**From:** Anna Slocum  
**Sent:** Wednesday, March 14, 2018 2:12 PM  
**To:** Amy McClure  
**Subject:** RE: Pool Options

The designs I am sharing are for your eyes only. This is the first pass of possible pool designs – indoor and outdoor.

OPTION 1  
 $\frac{1}{8} = 1'-0"$

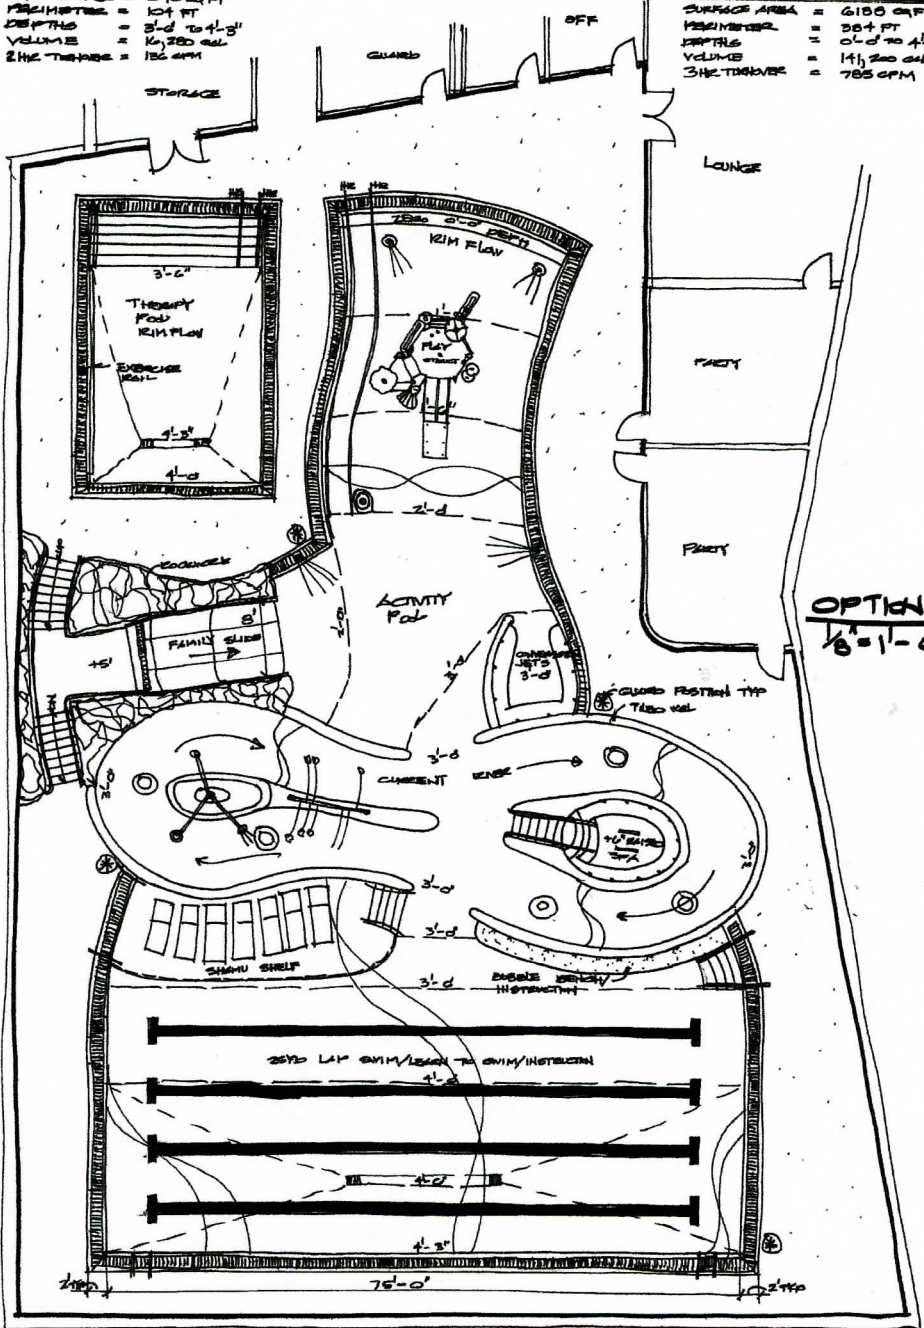
I like the set up of #1 mainly because it seems to flow better.

OPTION 2  
 1/8" = 1'-0"

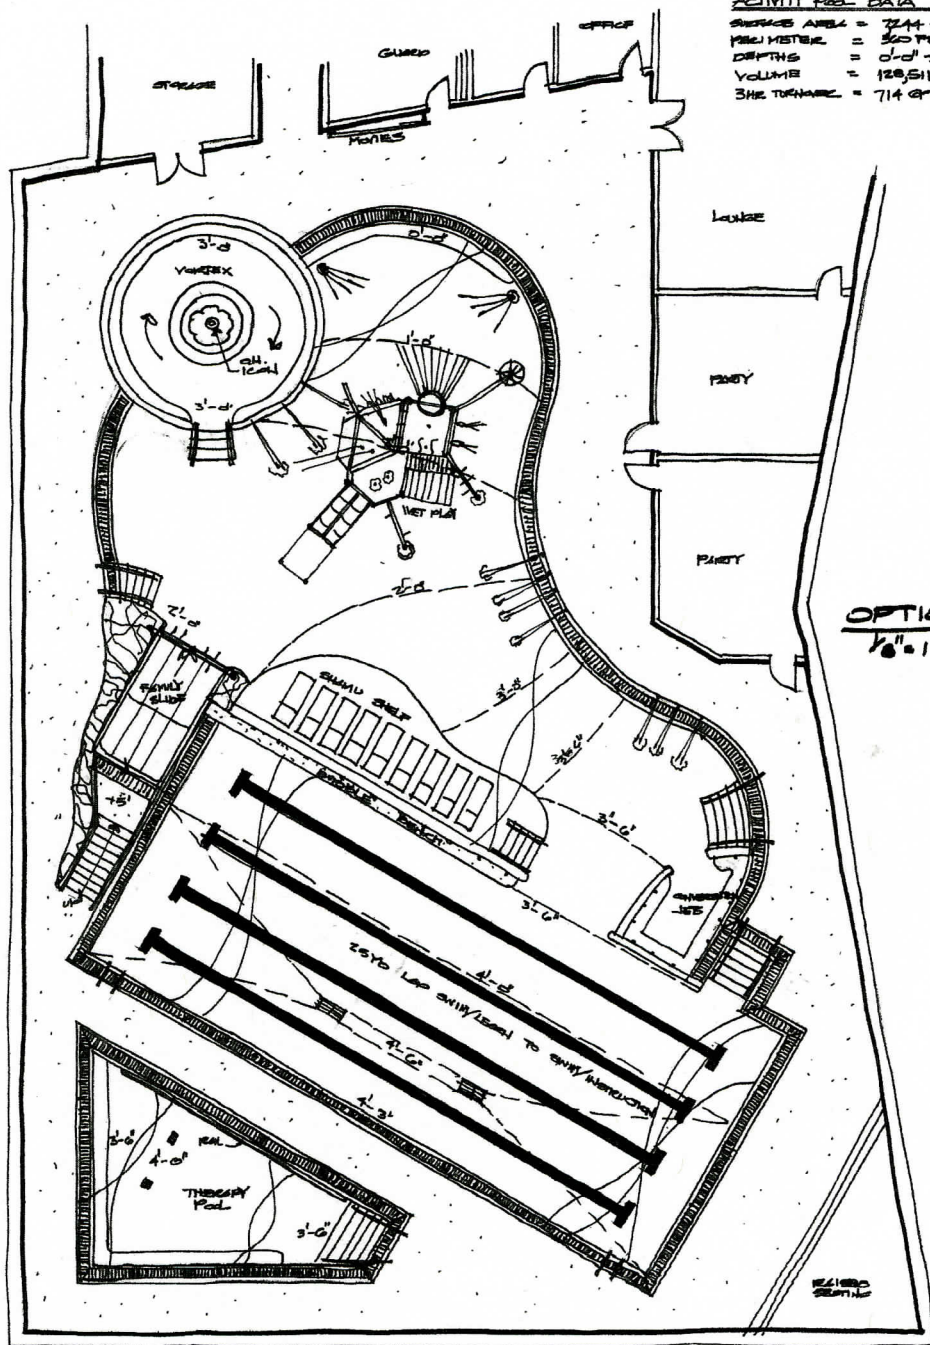
In #2, I like the idea of having the therapy pool away from the kids area due to loud noise and splashing. But I do not like the lap pool being at an angle. And I'm not sure what a vortex is, I assume it's a slide but I don't understand the function.

OPTION 3  
 1/8" = 1'-0"

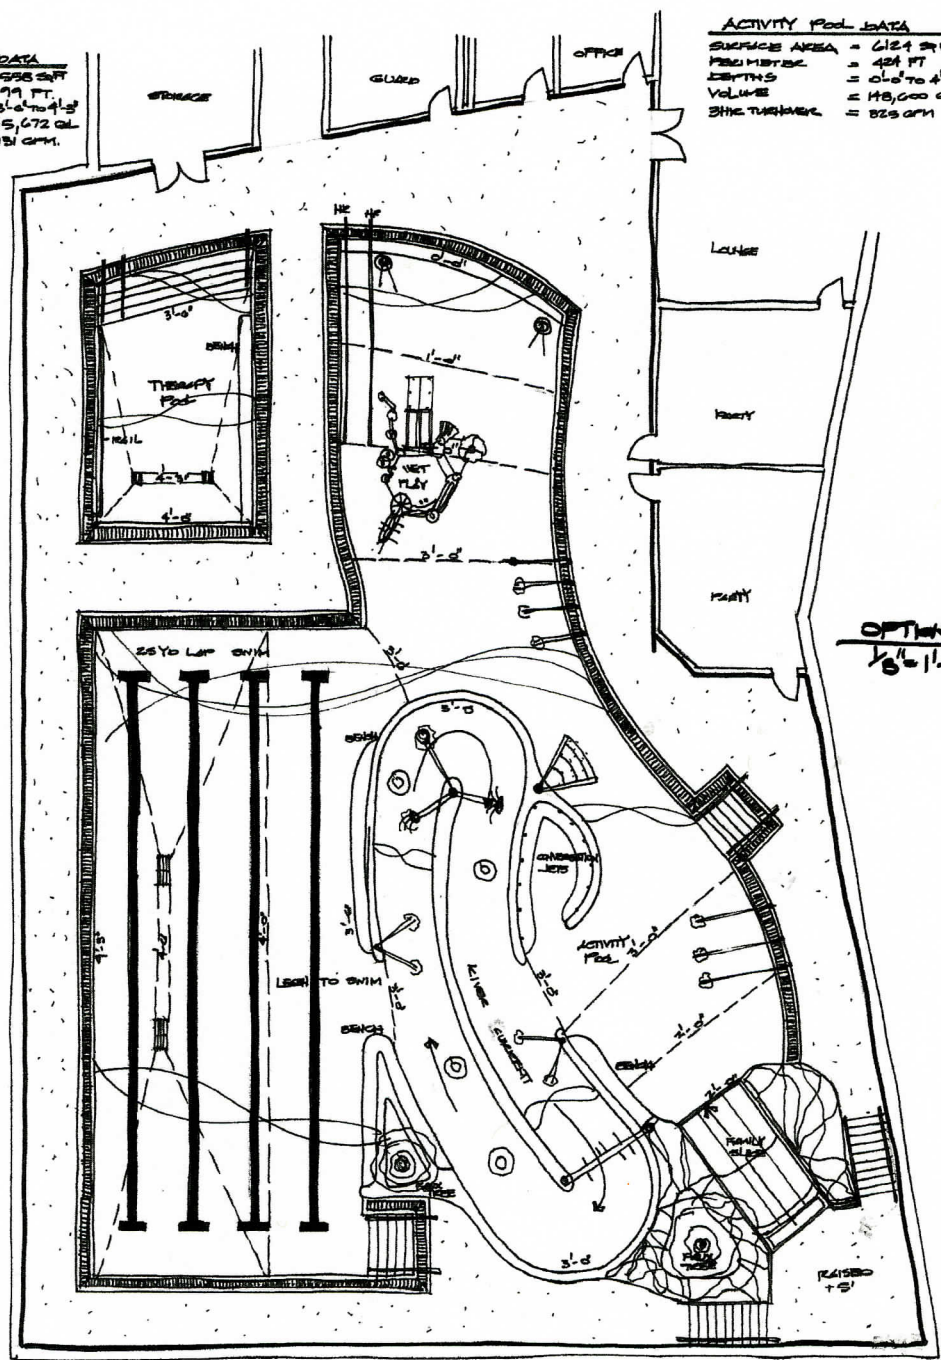
I like #3 also because of the flow of the layout.

OUTDOOR POOL DATA  
 SURFACE AREA = 4009 SQ FT  
 PERIMETER = 282 FT  
 DEPTHS = 3'-0" TO 12'-3"  
 VOLUME = 233,122 GAL  
 CIRC TO = 648 CFM

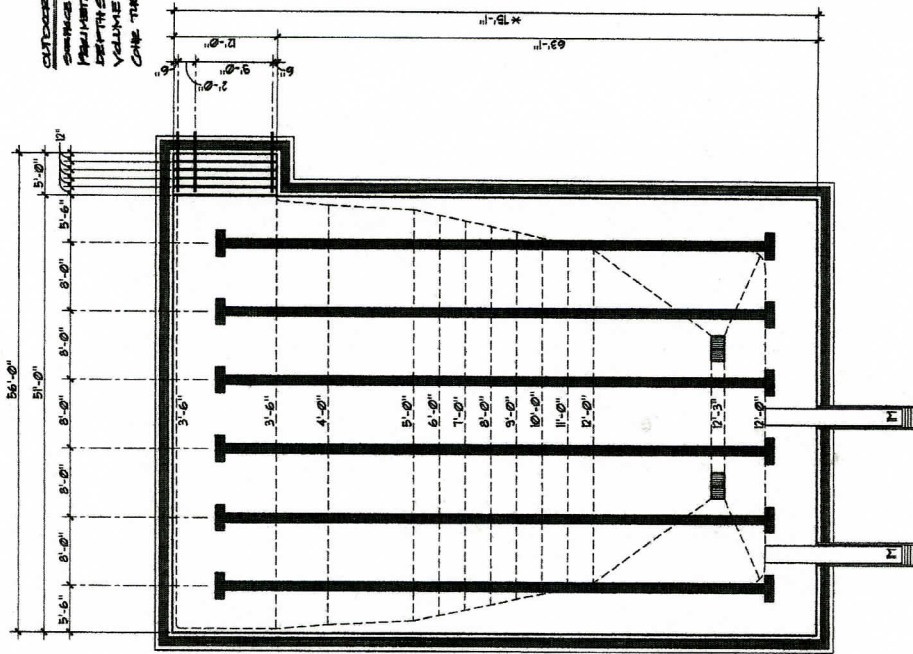
The outdoor design lacks any attractions that may bring families to our facility.

A 6 lane pool is not conducive to hosting swim meets. A competition pool has 8 lanes. With diving boards in the 12 foot, you will need a recommended 4 feet depth for starting blocks on the opposite end. This design has 3'6" depth.

A spray park doesn't really add to the idea of an aquatic facility. It sounds more like an attraction for a park.

If I had to choose between these two designs, I would pick #2. Only because it's slightly bigger with the added area around the steps.

Consider this point of view... from an operational and cost benefit standpoint – why would we spend the bulk of the money on a facility that is going to operate about 90 days / year? Also, this is no longer a seasonal facility so the goal is to entice people to purchase an annual membership, what amenities do we need to sell this year-round to families? If looking for a return on investment the more we pack indoors the better our rate of membership will be. Remember, when a pass is purchased whether annually or seasonally, they will have access to both the indoor and outdoor area as well as the other amenities of the building. That being said, I agree the outdoor pool is lacking a wow factor of just a 25 meter pool. Although I would anticipate the new aquatic coordinator to try and build the swim team back - I am not sure what luck we will have after a year of not having one. But if it is revived, the starting blocks will be on the diving board end and the boards will be “lifted” to allow for the lanes to be used as the start which is typical when dive and swim meets are not happening at the same time. Since we meet with the designer tomorrow I am wondering if there are site restrictions and that is why we are limited to 6 lanes – although not ideal, 6 lanes will function for a meet – Gladstone runs meets with 4 lanes!

I understand your concern about the spray park, but the idea is that will allow for “shoulder” season outdoor when the weather allows and does not require staffing – which since it is part of the facility will also help when the indoor pool is scheduled for lessons or classes.
